RIDEM PRELIMINARY DETERMINATION SUBMISSION

YAWGOO VALLEY ROAD ACCESS DRIVE

LOCATED ON YAWGOO VALLEY ROAD
EXETER, RHODE ISLAND

SITE LAYOUT PLAN
YAWGOO VALLEY ROAD ACCESS DRIVE
ASSESSOR'S PLAT 77-1 LOT 1
CITY/TOWN, RHODE ISLAND
PREPARED FOR:
TYLER GOVERN
14 SPENSTONE ROAD
CRANSTON, RHODE ISLAND 02910
DESIGN BY: J.A.R. DESIGN BY: N.M.P.

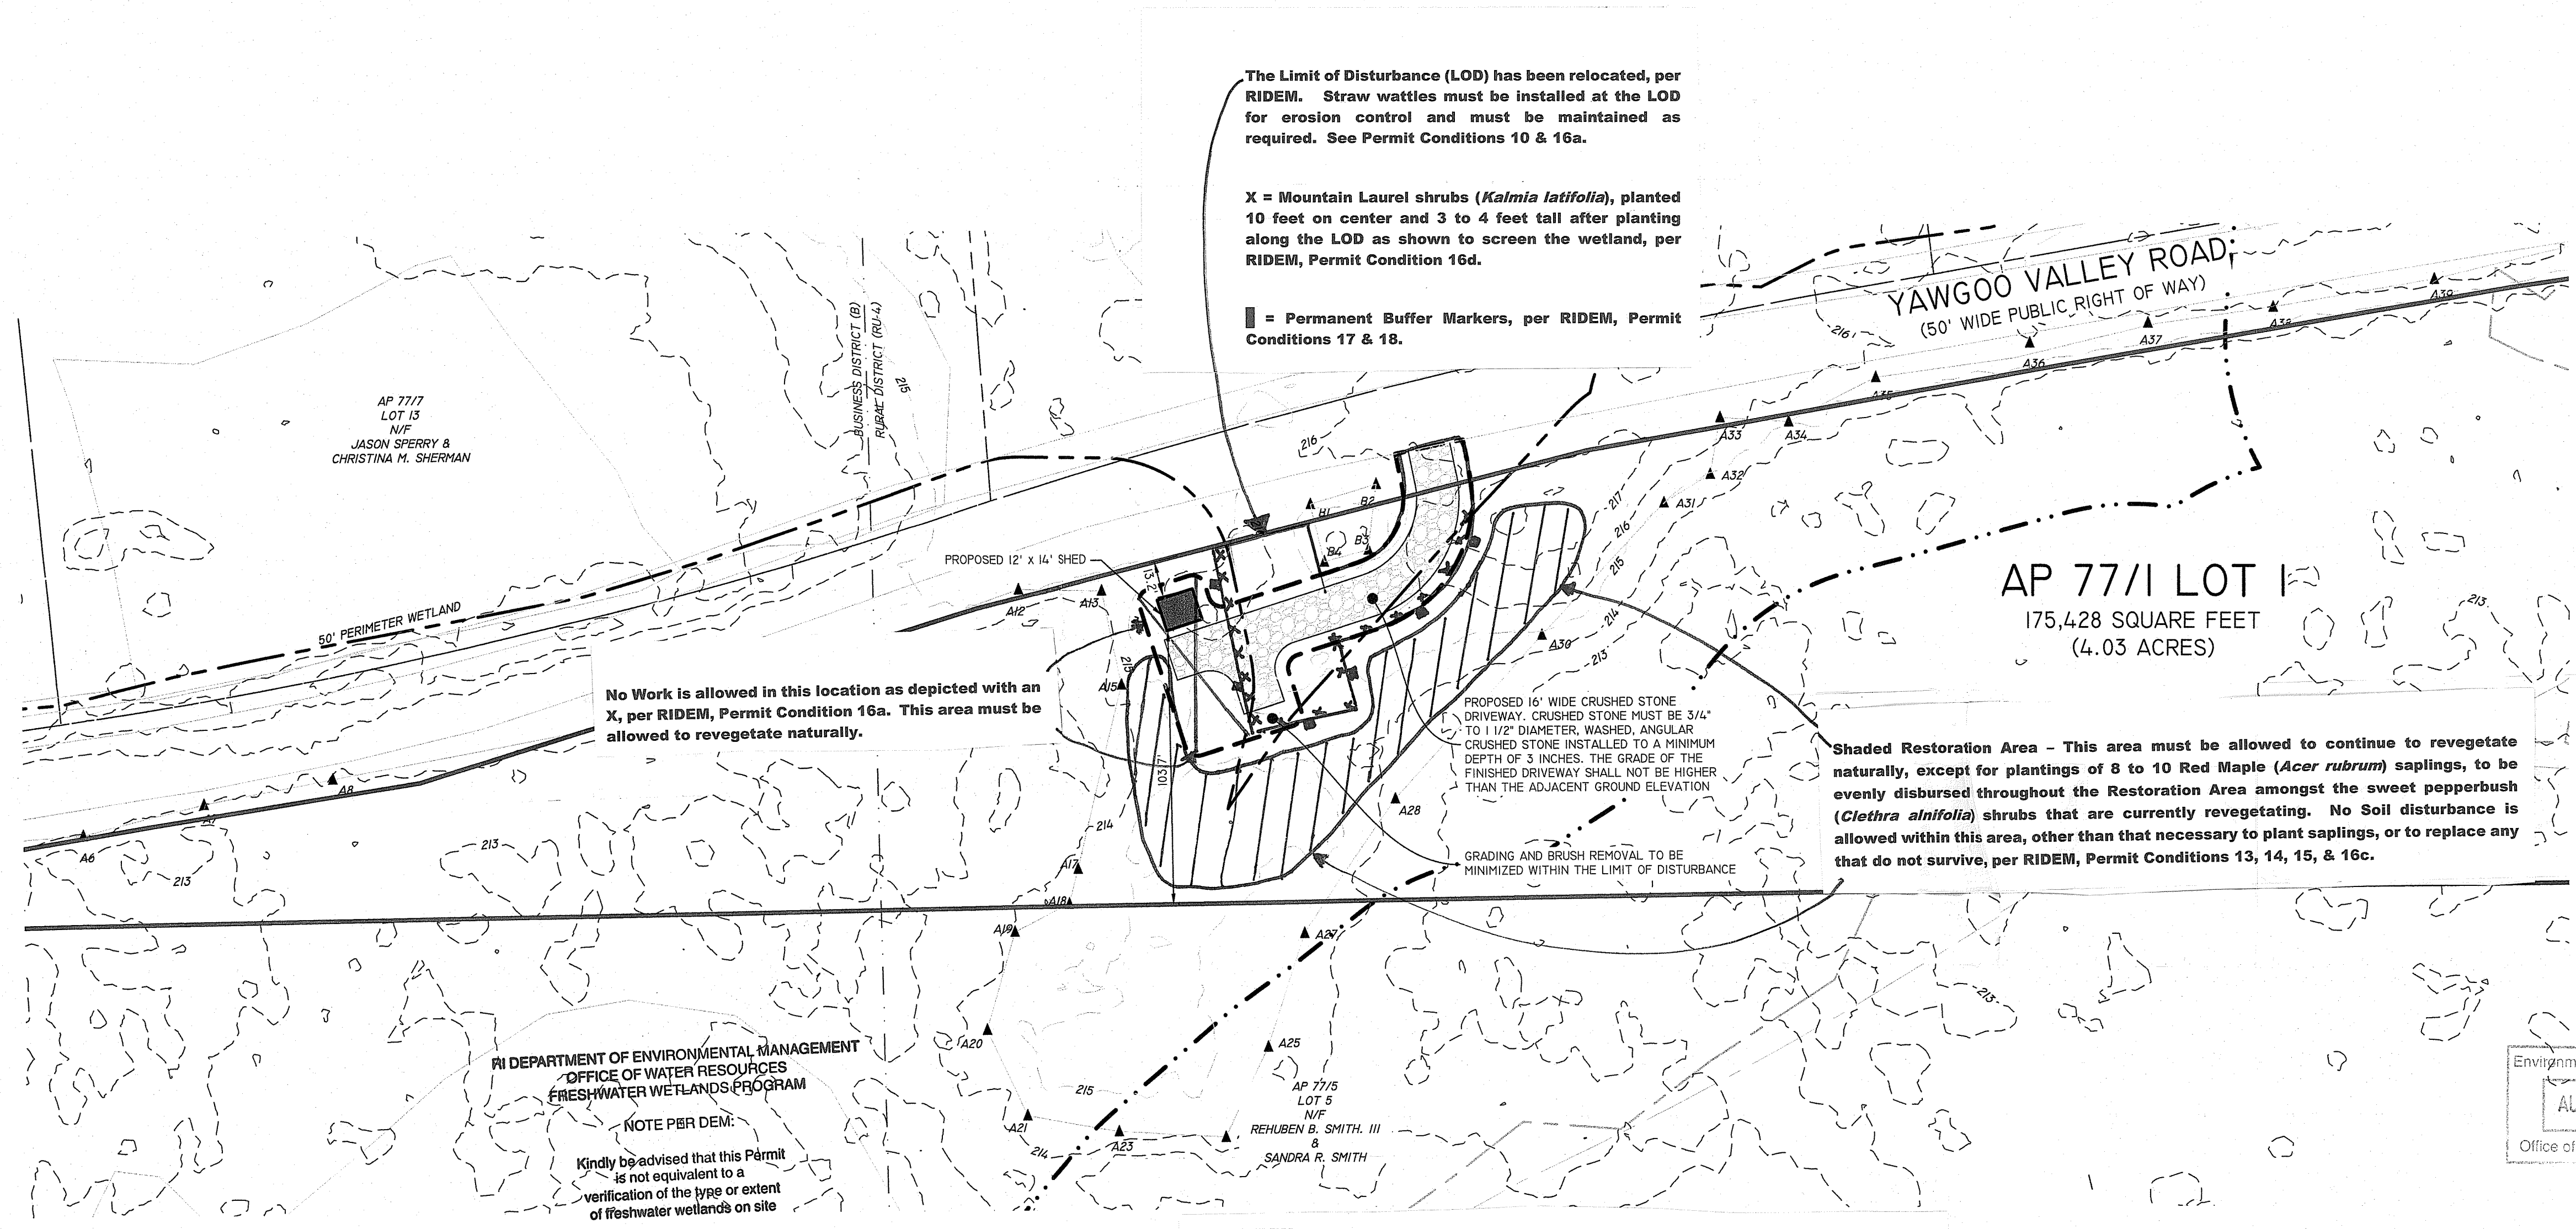
- Per RIDEM:**
1. The disturbed swamp must be allowed to revegetate naturally, per Permit Condition 16a.
 2. Woody debris piles located in swamp near wetland flags A28 through A30 must be removed from the swamp by hand and disposed of in an upland location by July 15, 2023, per Permit Condition 16a.
 3. The wooden structure that was installed without authorization in the 50-foot perimeter wetland for electrical power can be allowed to remain in its current location or relocated outside of all wetland areas.
